Model: Brz-P/MF PFU	Date: 17-Jan-17	No.: RD3C2001
Subject: PtoP Diagram Update		Prepared by: T. Tachibana
From: 2nd Tech Service Sect., MFP/P Tech Service Dept.		
Classification:	<input type="checkbox"/> Troubleshooting <input type="checkbox"/> Mechanical <input type="checkbox"/> Paper path <input type="checkbox"/> Product Safety	
	<input checked="" type="checkbox"/> Part information <input type="checkbox"/> Electrical <input type="checkbox"/> Transmit/receive <input type="checkbox"/> Other ()	
	<input type="checkbox"/> Action required <input type="checkbox"/> Service manual revision <input type="checkbox"/> Retrofit information <input type="checkbox"/> Tier 2

Model: Brz-MF1/P1 PFU PB1100		Date: 2-Nov-17	No.: RD3C2002
Subject: Parts Catalog correction: Paper feed tray size switch		Prepared by: T. Tachibana	
From: 2nd Tech Service Sect., MFP/P Tech Service Dept.			
Classification:	<input type="checkbox"/> Troubleshooting <input type="checkbox"/> Mechanical <input type="checkbox"/> Paper path <input type="checkbox"/> Product Safety	<input checked="" type="checkbox"/> Part information <input type="checkbox"/> Electrical <input type="checkbox"/> Transmit/receive <input type="checkbox"

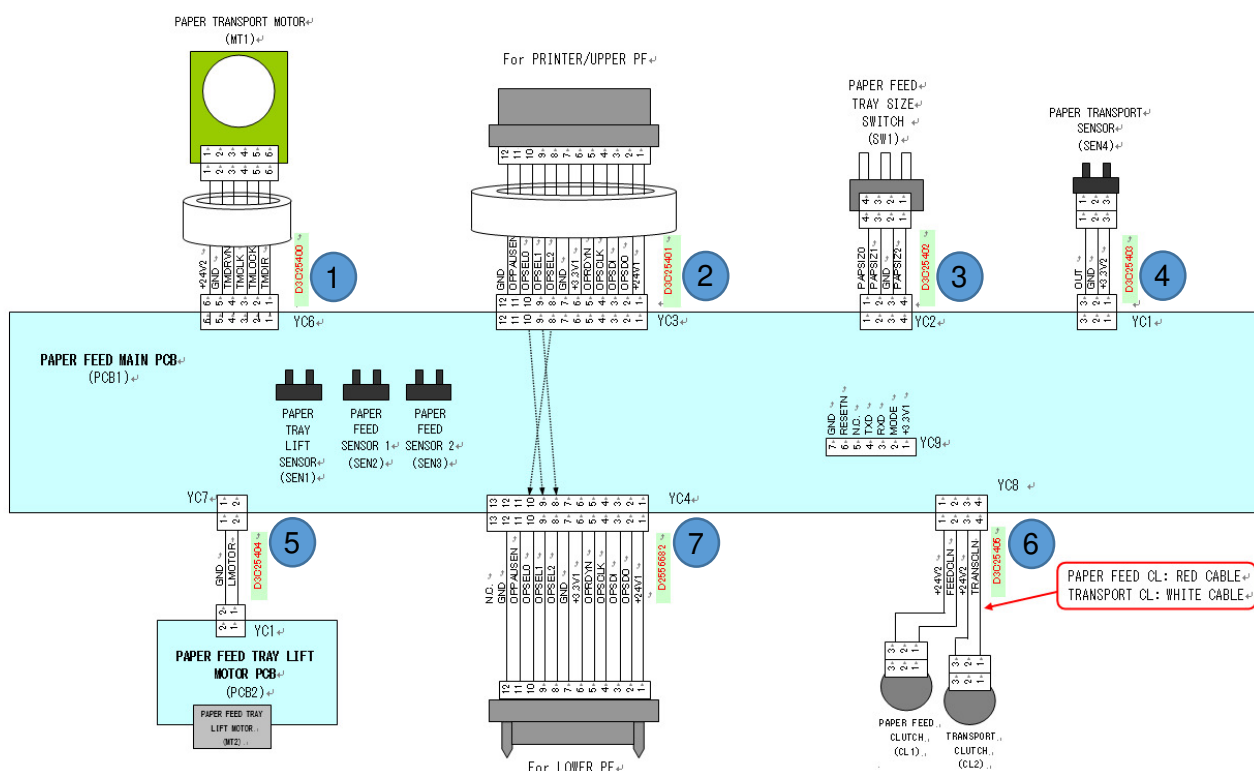
Change: These parts are newly added.

Reason: These parts were missing from the point-to-point diagram.

Part number	Description	Note
D3C25400	CONN.CORD ASSY S03758	Shown as #1 in the diagram.
D3C25401	CONN.CORD ASSY S03759	Shown as #2 in the diagram.
D3C25402	CONN.CORD ASSY S03760	Shown as #3 in the diagram.
D3C25403	CONN.CORD ASSY S03761	Shown as #4 in the diagram.
D3C25404	CONN.CORD ASSY S03762	Shown as #5 in the diagram.
D3C25405	CONN.CORD ASSY S03764	Shown as #6 in the diagram.
D2556682	CONN.CORD ASSY S04107 PF-PF	Shown as #7 in the diagram.

1.Paper Feed Section-1

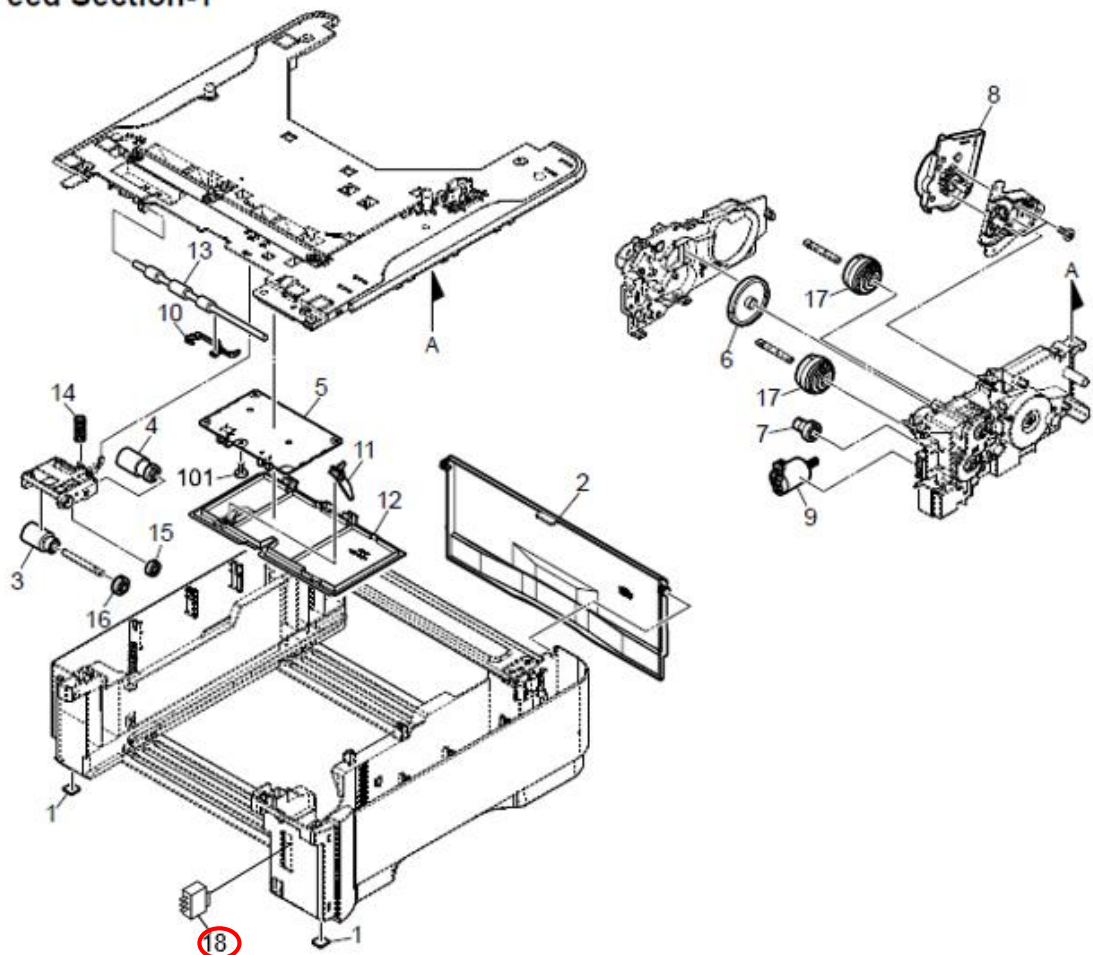
Change: These parts are newly added.

Reason: To meet requests received from the field.

Part number	Description	Q'ty	Int	Page	Index	Note
M2812860	SW.PUSH	1		2	18

1.Paper Feed Section-1

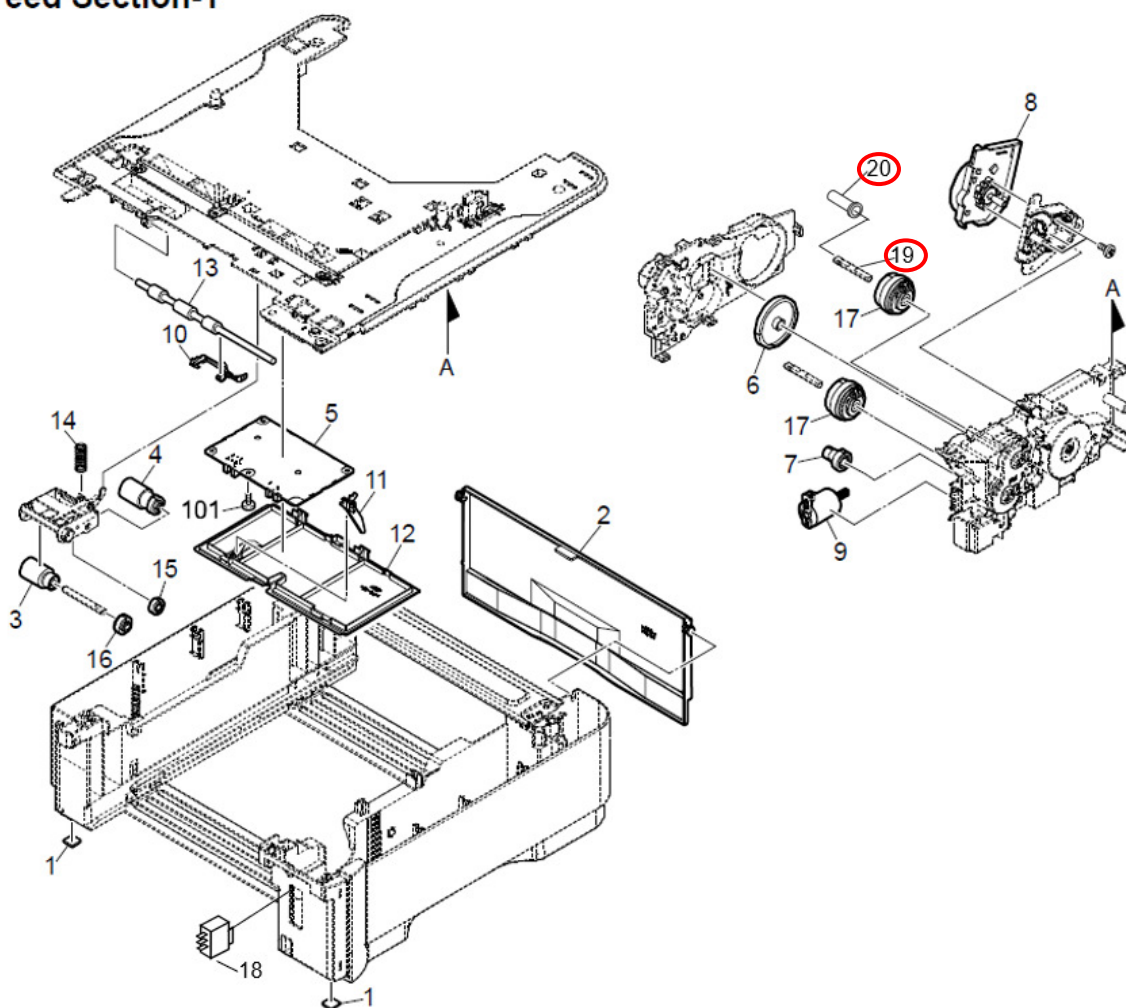
Change: These parts are newly added.

Reason: To meet requests received from the field.

Part number	Description	Q'ty	Int	Page	Index	Note
M2811132	SHAFT FEED CLUTCH	1	-	2	19	
M2811131	JOINT FEED	1	-	2	20
